UNITED STATES PATENT AND TRADEMARK OFFICE

| APPLICATION NO. | FILING DATE | FIRST NAMED INVENTOR | ATTORNEY DOCKET NO. | CONFIRMATION NO. |
|--|-------------|----------------------|--------------------------|------------------------|
| 10/573,627 | 03/28/2006 | Heiko Roehm | 3582 | 5660 |

Office Action Summary

DETAILED ACTION

Fig. 1

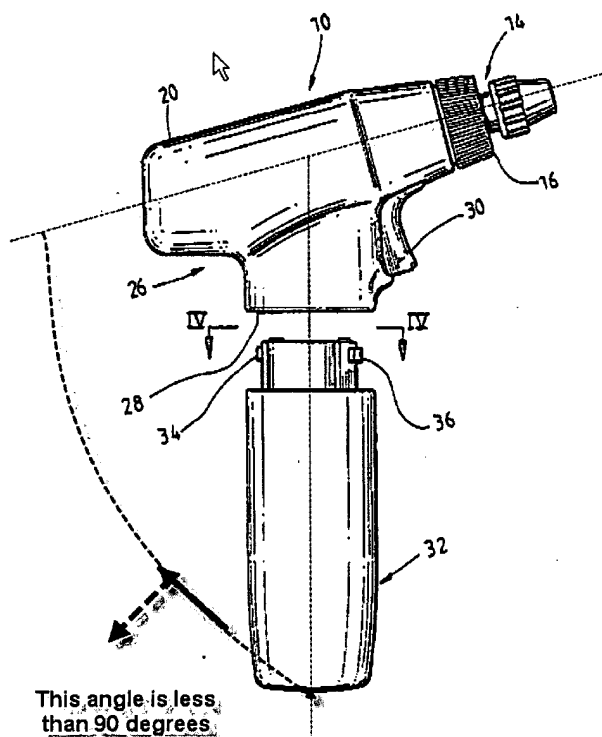
Kilmer discloses (col. 2, lines 36+; col. 3, lines 62+; col. 4) and shows in Figs. 8 – 10, a charger shell (60) having embedding means (32',62,64) on its top surface (see Fig. 8) for receiving the portable power tool (10) (col. 2, lines 36+; col. 3, lines 62+; col. 4) which correspond to a copy of its internal angle outer surfaces that are enclosed by the handle (32') (considering the axis of (10) to be the vertical) and the motor housing (casing (20)) and the gear box (18); and that at least one of the embedding means (32') extends at an angle of less than 90° to the vertical (see Figure 1 below).

Accordingly, claims 5-6 would have been obvious.
